Zoning Challenge and Appeal Form

BIS Job Number 122887224

Street Name Amsterdam Avenue

RE: Zoning Challenge 200 Amsterdam
Block 1158, Lot: 133, Job No:
122887224, Doc. 7

Plan of block 1158 with existing buildings, street addresses, tax and zoning lot lines

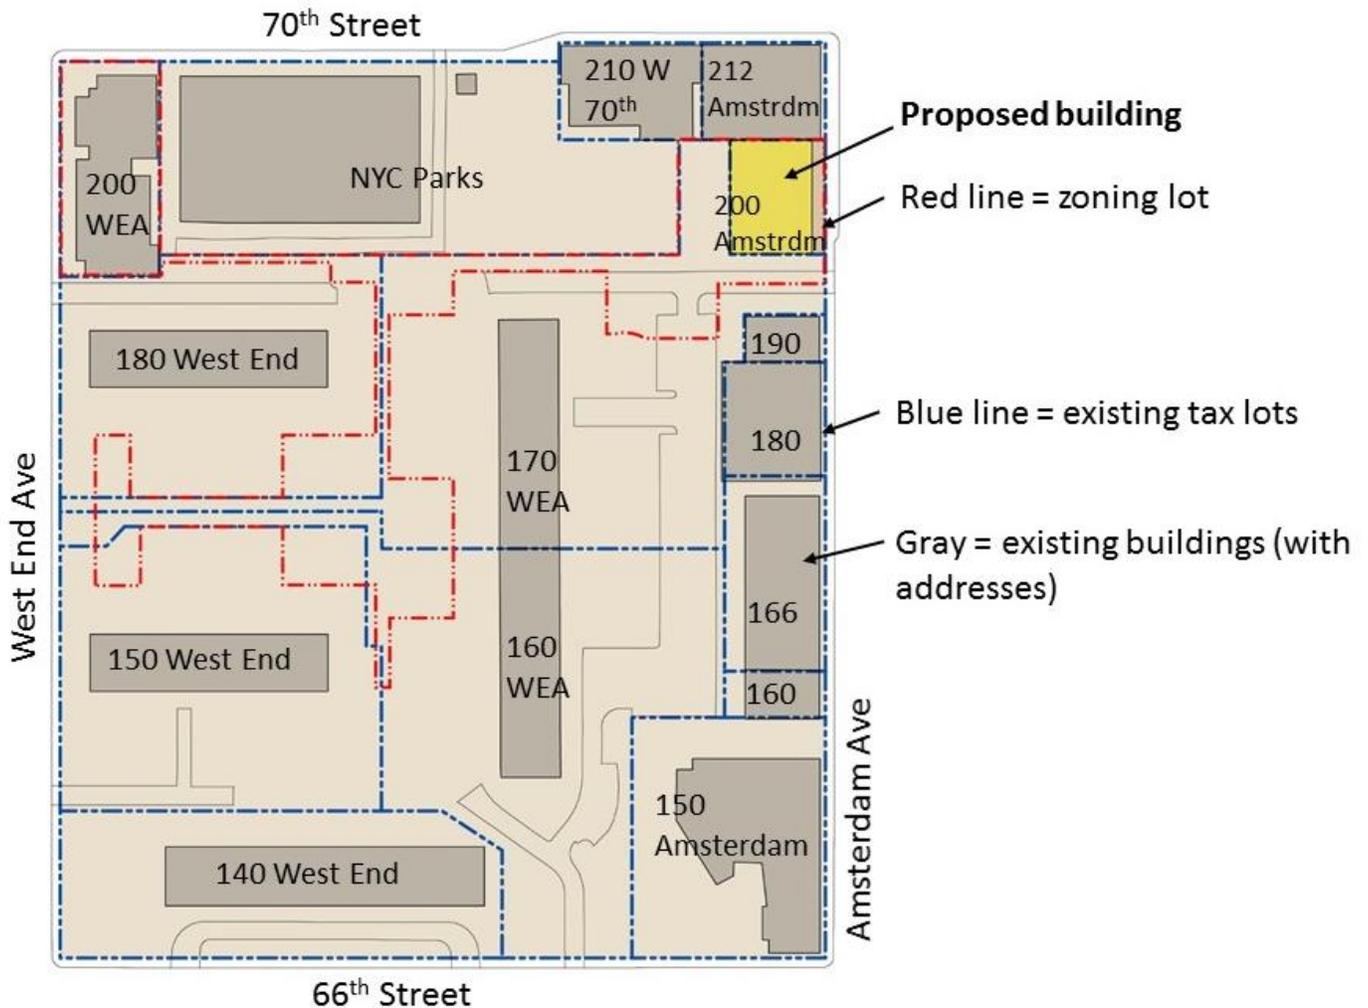
It obtains its exceptional height, in part, because ample floor-to-floor heights and large mechanical spaces; building mechanicals are enclosed in the top four floors of the building and are 67 feet tall. Most of its exceptional height, however, results from floor area generated by the enormous size of the irregular zoning lot on which it sits, which is 110,794 SF. The zoning lot is gerrymandered over much of superblock 1158; portions of it front West End Avenue, 70th Street, and Amsterdam Avenue. The zoning lot is partially a corner lot, partially a through lot, and mostly an interior lot.

The oddly shaped zoning lot is not new but was not well-known until recently. An extremely large zoning lot that included most of the superblock was created on the site in 1987. According to my office's research, the first gerrymandered lot was developed in 2007 and amended at least one time in 2016.

*Areas covered by the 1987 zoning lot classified by use of land (with 200 Amsterdam shown as constructed).
Gerrymandered zoning lot of 200 Amsterdam and 200 West End Avenue shown in red*

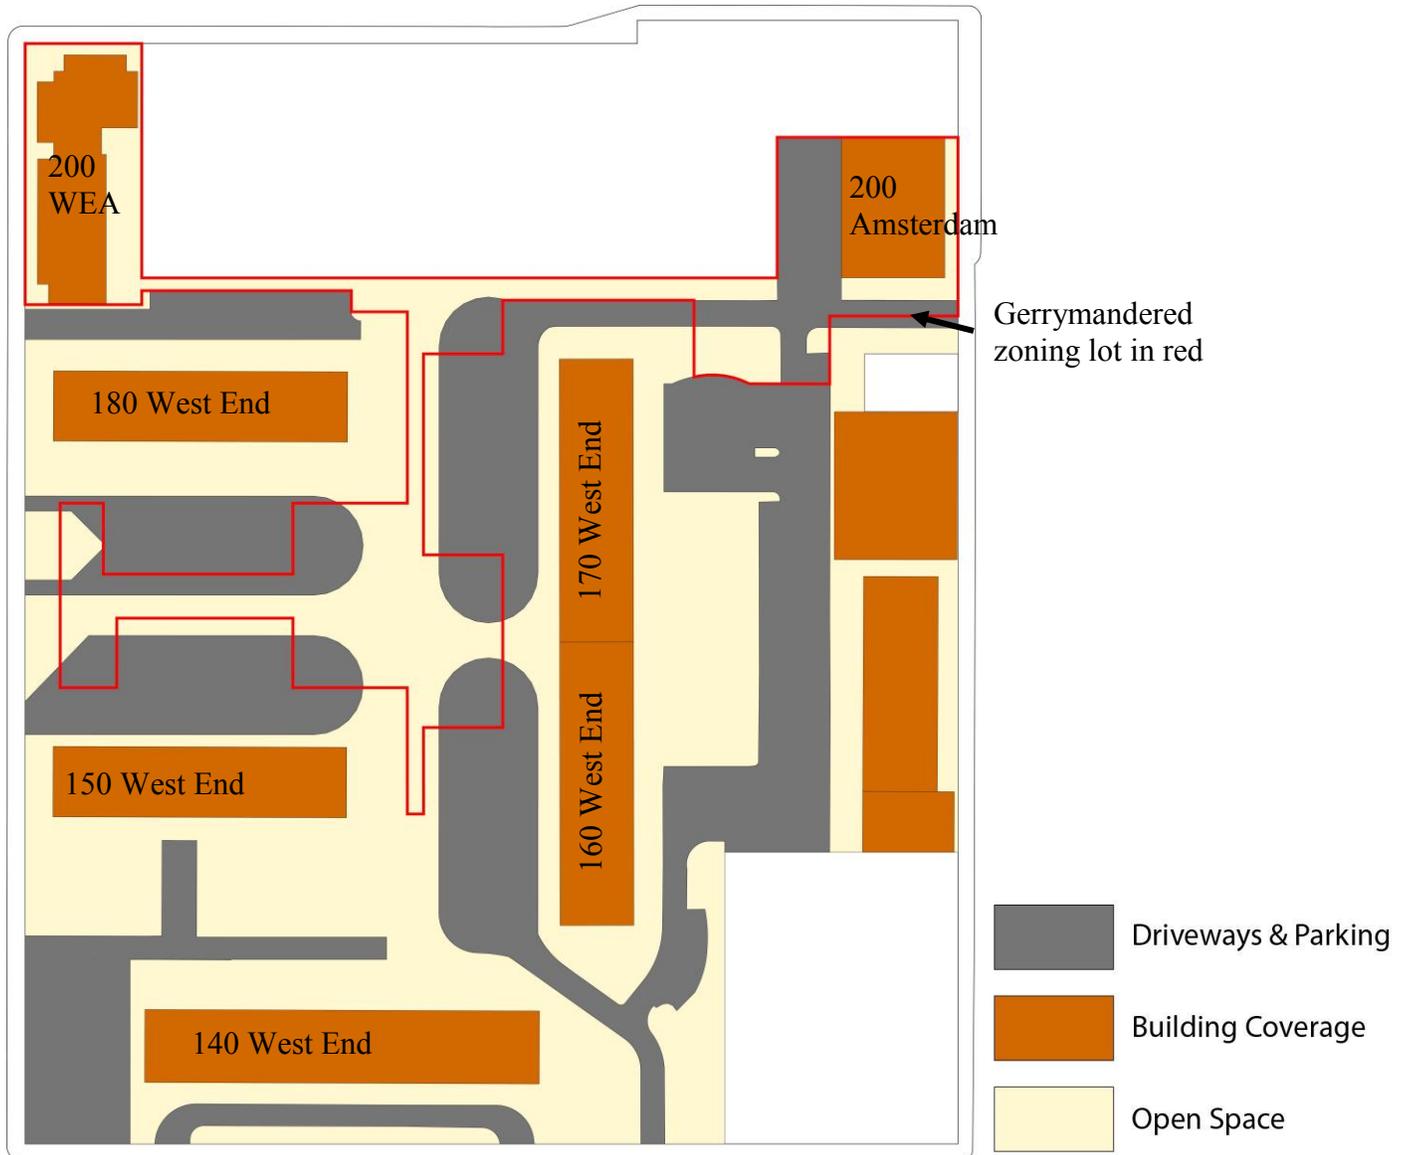
As stated in the Zoning Resolution, up to 50% of the required open space may be accessory parking, driveways, loading docks and bike parking. These uses are shown in gray above.

By my office's calculations, 33,983 SF of the open space on the gerrymandered lot is used for driveways and parking. According to 12-10, an Accessory use:

The parking and driveways are accessory to the uses on the Lincoln Towers zoning lot. They are not accessory to the uses on the gerrymandered lot since there is no parking provided for 200 Amsterdam or 200 West End Avenue. Uses accessory to another zoning lot are not permitted obstructions in Open Space, and thus, the 33,983 SF cannot be counted as open space in 200 Amsterdam's zoning calculations.

The building still complies according to FAR, but has nowhere near enough open space. At 8.7, the required Open Space ratio is 4.7 points too low, which is an *enormous* amount of open space considering the size of the development. I acknowledge that the measurements and the delineation of the parking areas was done from aerial photographs, and a survey of these areas could result in different measurements. But the amount of difference conceivable from a survey would not change this level of non-compliance: about 80% of the area now used as parking and driveways accessory to Lincoln Towers would have to be reclassified to complying open space for 200 Amsterdam to even approach compliance with the required open space ratio.

The sky exposure plane proposed for 200 Amsterdam. The top four floors break the sky exposure plane.

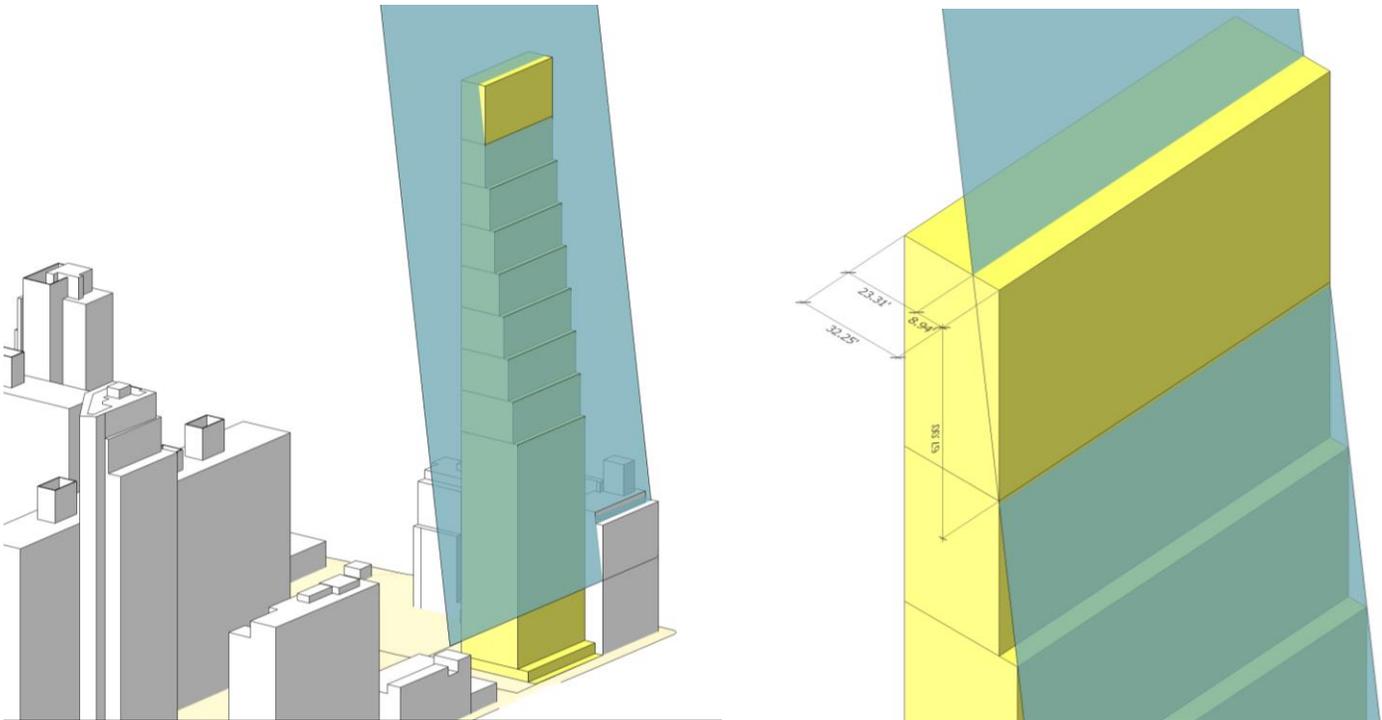
The ZD1 states, in effect, that the mechanical equipment located in floors 51 through 55 are permitted obstructions under 23-62(g). The question as to if the in-building mechanical floors may penetrate the sky exposure plane as a permitted obstruction hangs on the definition of “enclosures.” Unfortunately, this is not a defined term in the Zoning Resolution, but the applicant claims, and the Department has agreed, that enclosures may mean exterior building walls. This interpretation is in error, however, as it is not consistent with the New York State Multiple Dwelling Law (MDL).

While it is not a defined term in the MDL, the expression “superstructure” is used here, and elsewhere in the MDL, to refer to a structure that is on top of a building. The obvious interpretation of the MDL is that building height is measured to the top of the roof, with fairly wide exceptions for rooftop mechanicals, parapet walls and the like. The less obvious--and I would say incorrect interpretation--is that the first 50 feet of mechanicals can be exempted from building height. Either way, at 67 feet, the top four mechanical floors break the prescribed sky exposure and should not be considered permitted obstructions to maintain consistency with the MDL, as required by law.

From 1961 to 2012, this text was consistent with the MDL; these obstructions are superstructures that are often screened by enclosures. In my opinion, the current text is also consistent with the MDL, but it has been interpreted incorrectly. The amendment was intended to explicitly include mechanical equipment on the roof that was enclosed to protect or screen it, which would be consistent with the MDL’s provision for “other mechanical equipment.” The problem is that the applicant’s aggressive interpretation of “enclosure,” suddenly means the building itself is not counted in building height if it contains mechanicals, which is clearly contrary to the MDL, and I believe to the intent of this recent text change.
